## Planning Commission

### Meeting Minutes

April 17, 2017

**V-18-2017 Variance**

**APPENDIX: Sheet A1.0 (architectural foundation plan)**

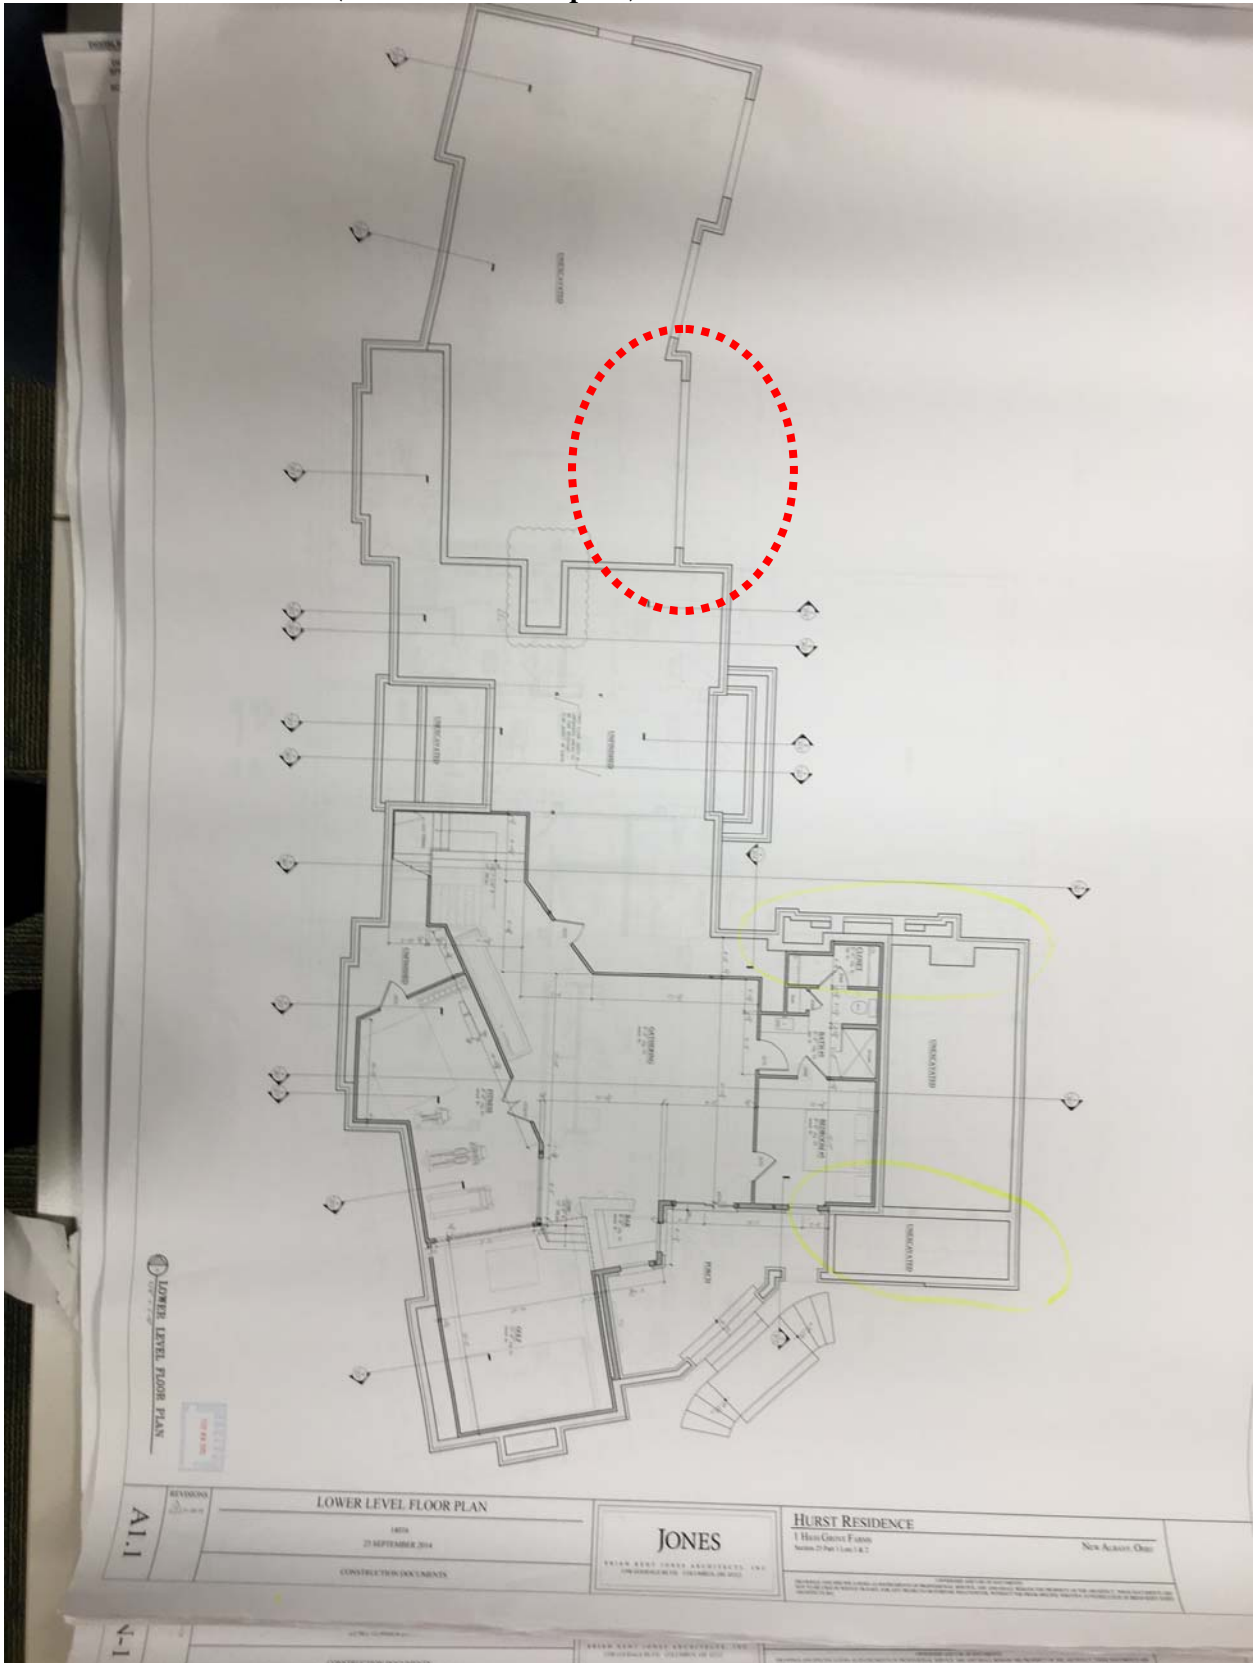
- a. Sheet A1.0 (architectural foundation plan) and sheet A1.1 (lower level floor plan) shows the doublewide garage door opening.
  - b. Sheet A2.1 (first floor plan) shows a frame to separate the doublewide garage door into two single doors. When cross-referenced with the “wall legend” on sheet GN.1 indicates a “2x4 or 2x6 wood stud wall” separating two garage door bays.
